From: Shannon McIntyre
City of Mobile Architectural Engineering Department

Re: Mims Park – Athletic Restrooms and Concessions

Project #PR-048-24B

Date: November 12, 2024

01 HARDSCAPE ENLARGEMENT & LAYOUT (ALTERNATE)
1" = 10'-0"

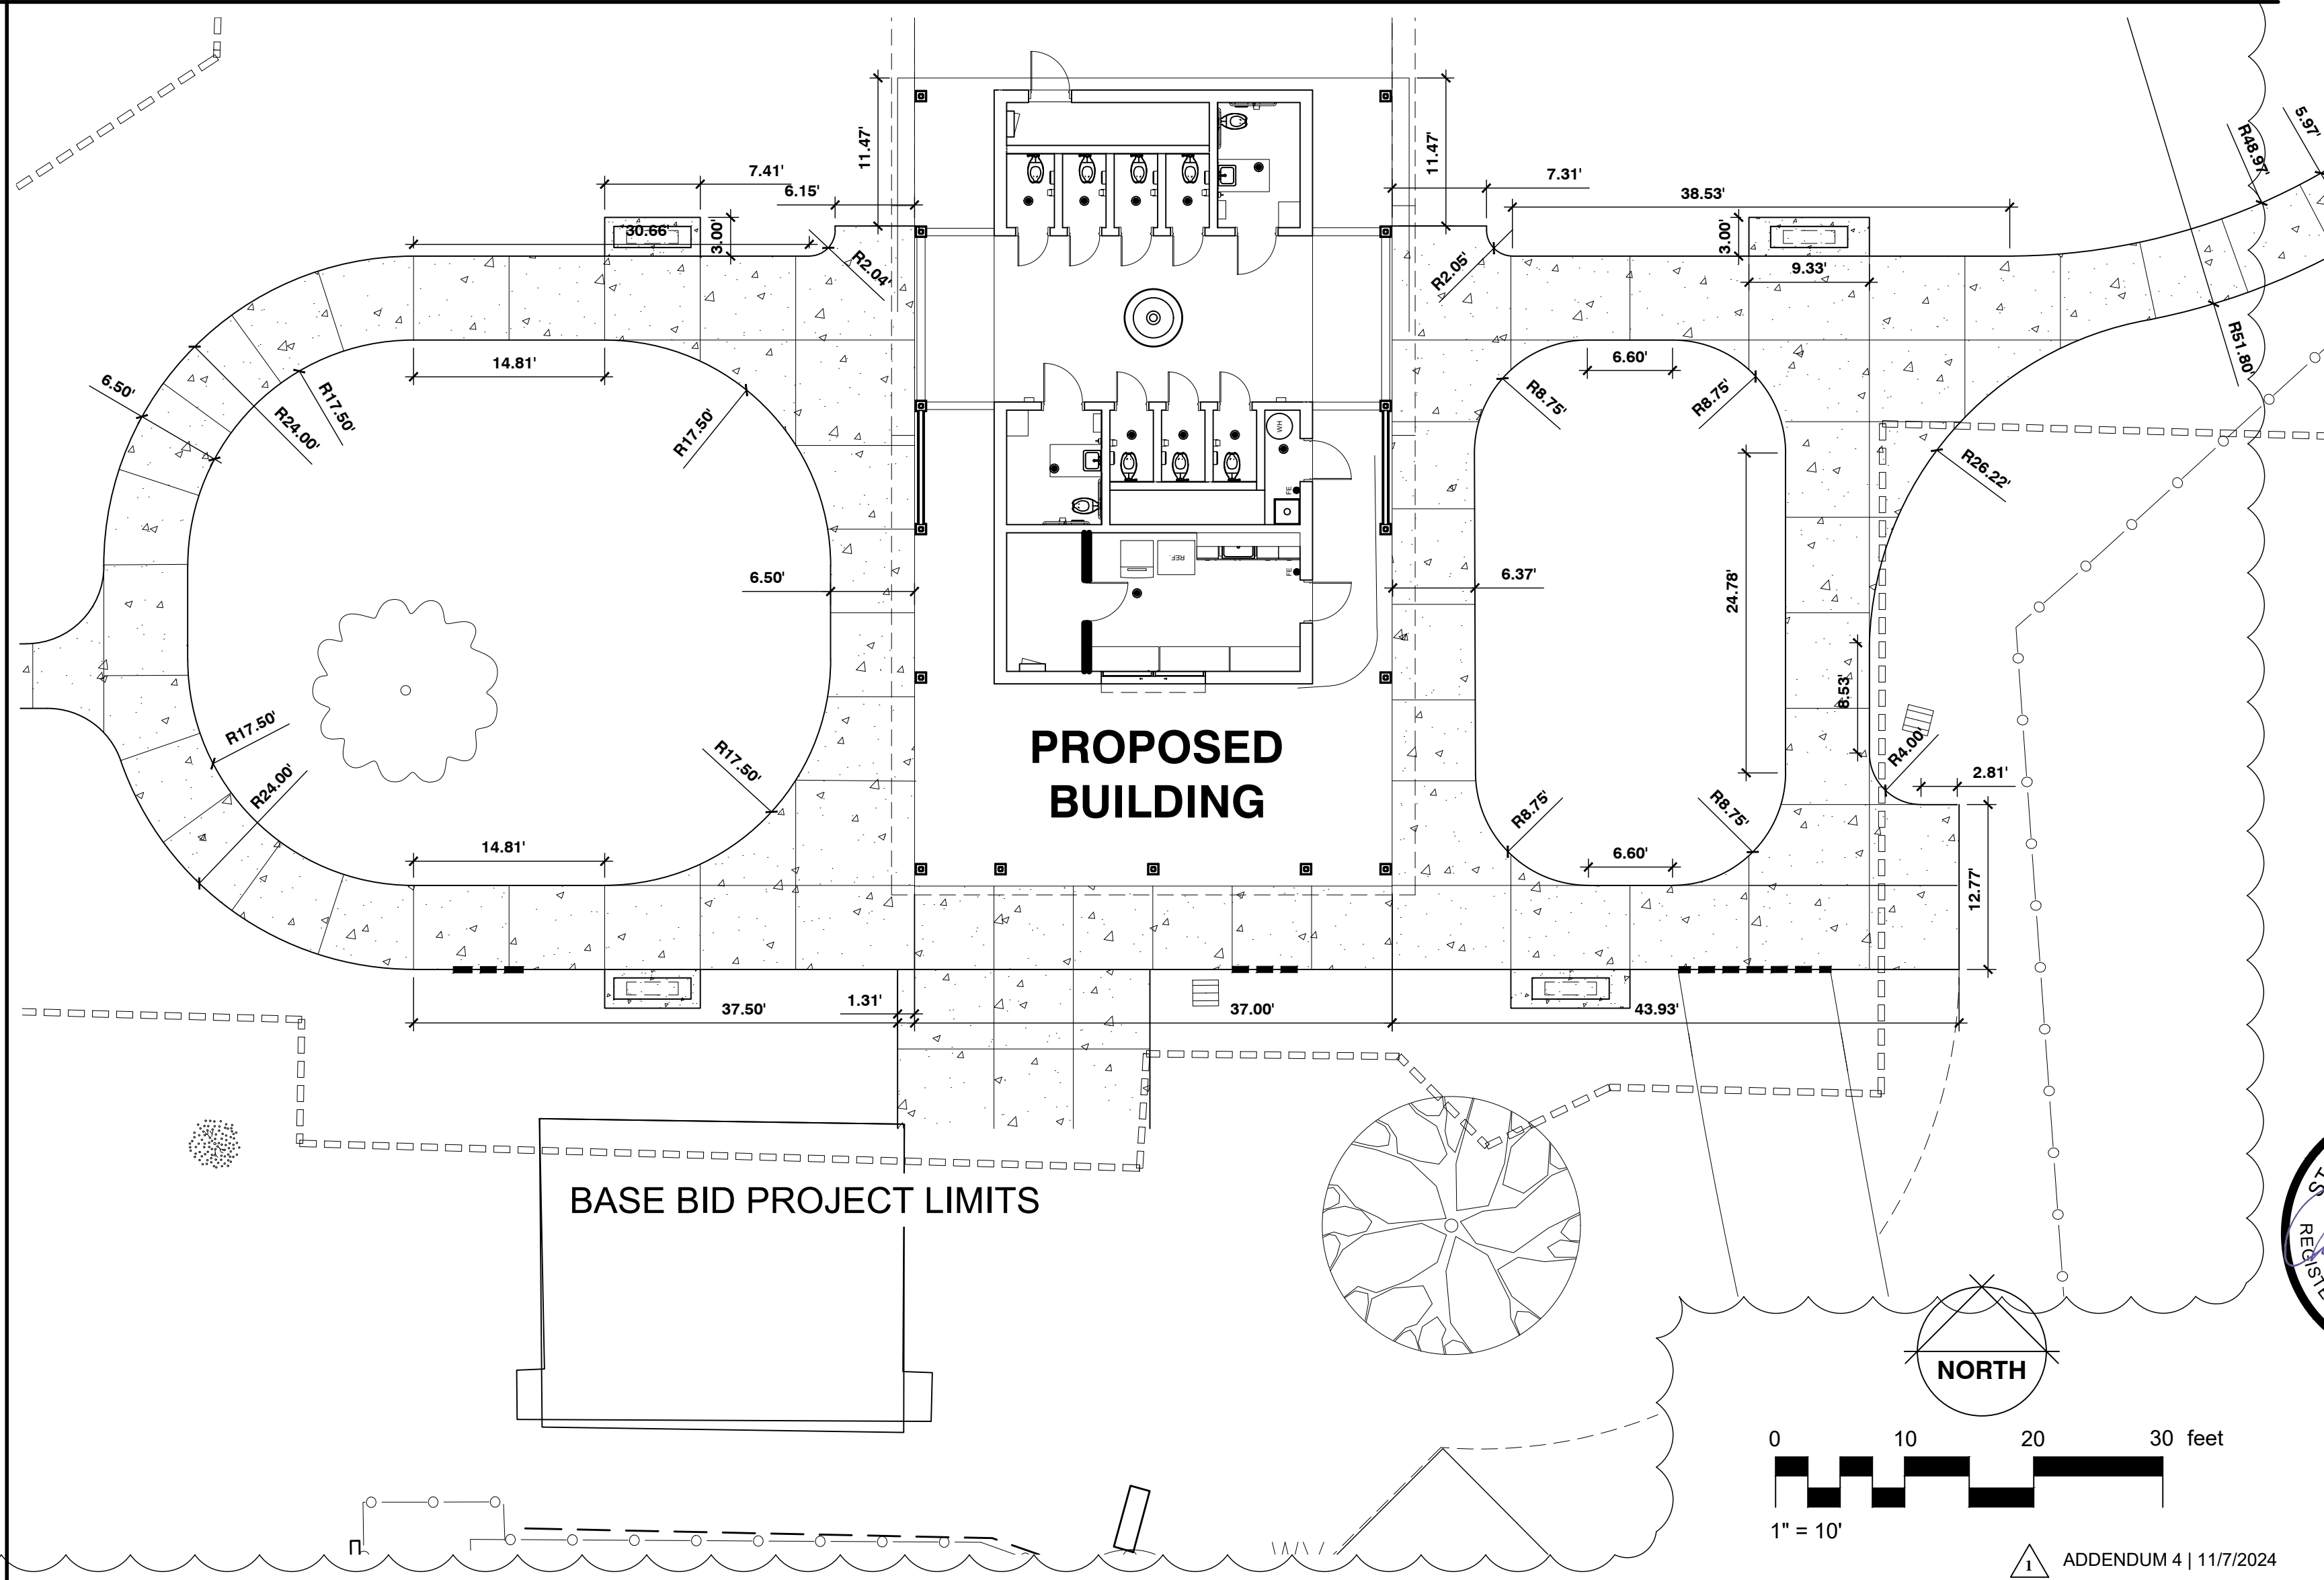
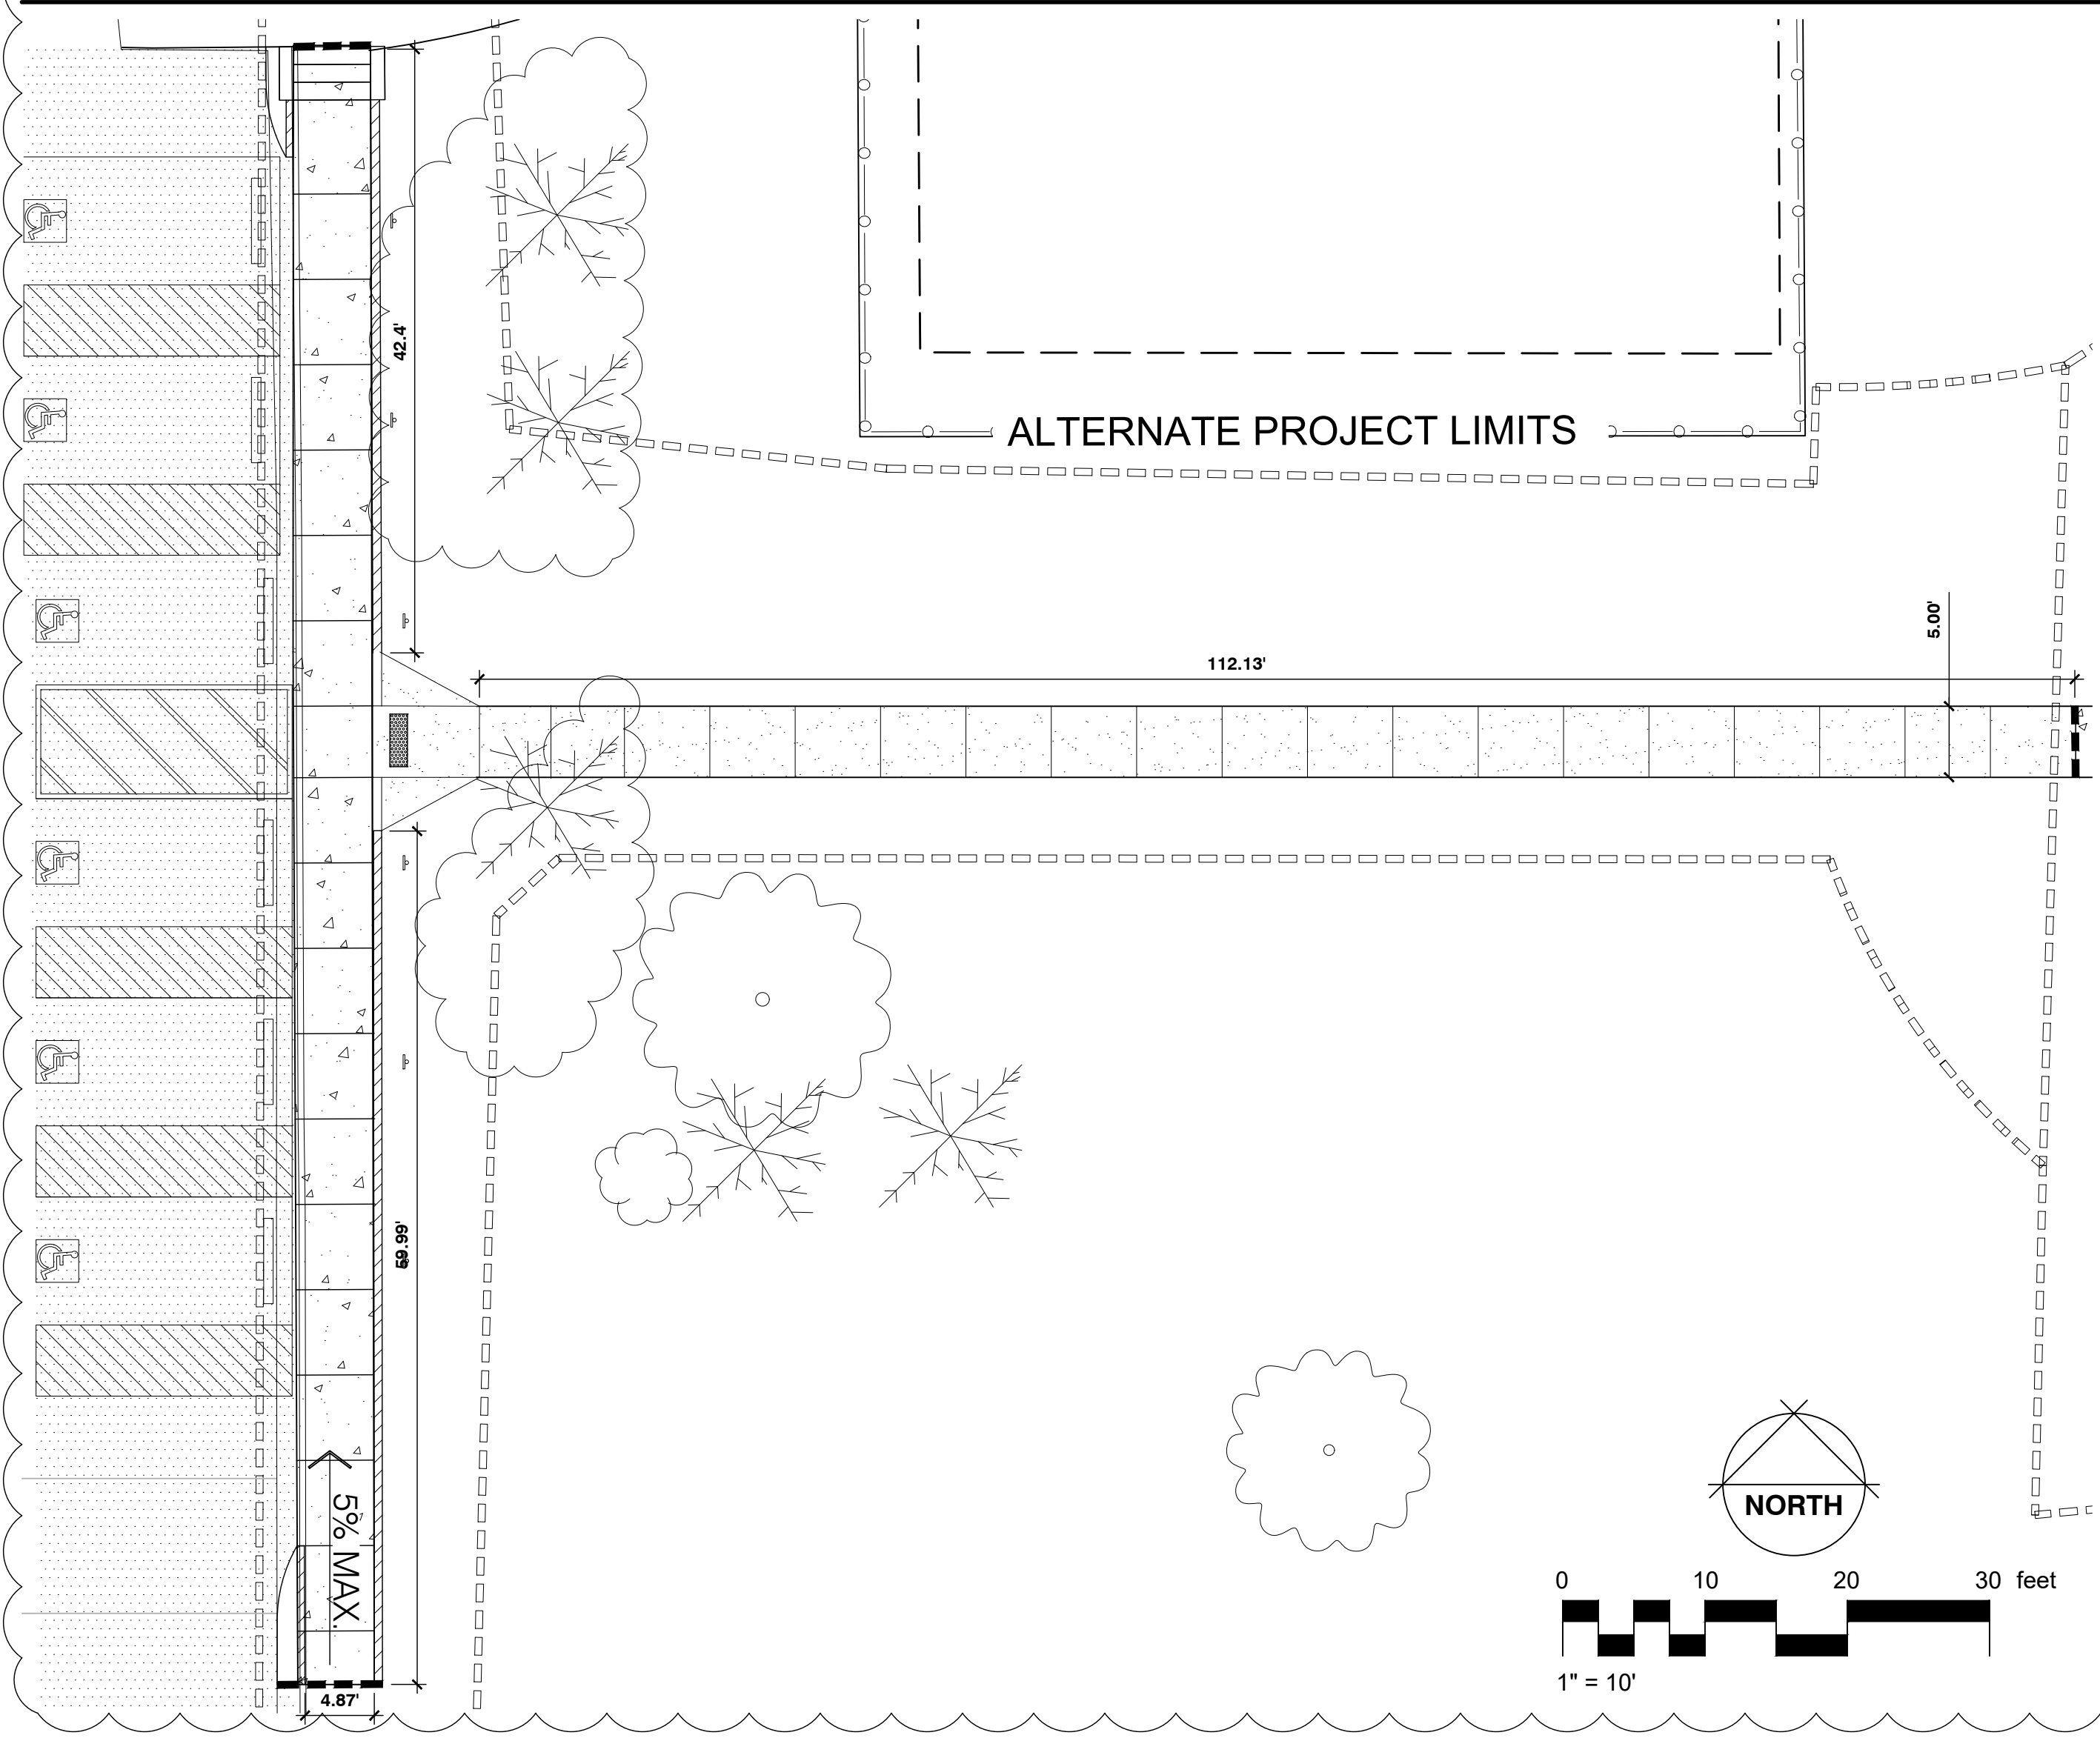
The scale on C3.0 appears to be correct. The alternate concrete sidewalk would be 1,263 SF. H100 Detail #1 Alternate is showing 886 SF of sidewalk alternate.

A: Reference Addendum 4 Sheet H100 for updated quantities
